## Technical change to HDC housings

PCN-number:	PCN-PB72-20220214-00-A
Date of publishing:	2022, February 14
Duration of validity:	Until further notice
Revision number:	00-A

Old version

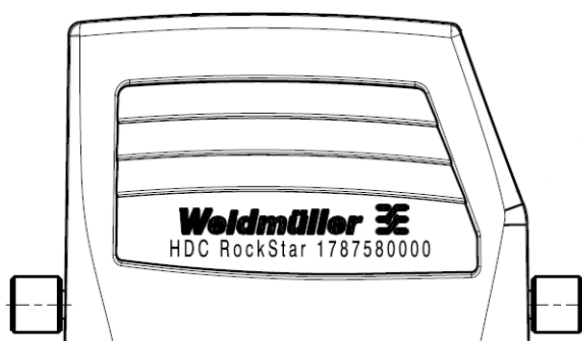
The marking of HDC RockStar housings was tampon-print in the past.

new version

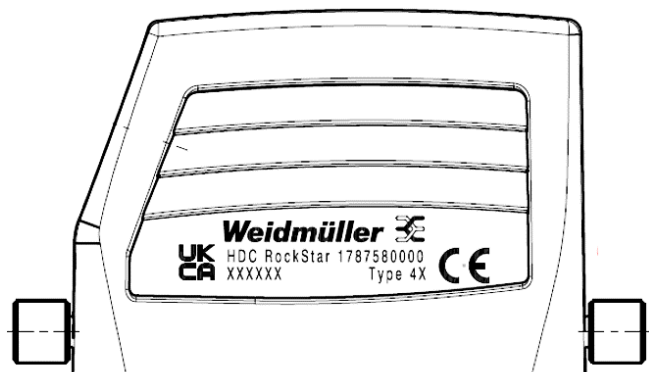
In the future the housings will carry a laser printing with order number, date code, UKCA and CE mark, as well as NEMA classification.
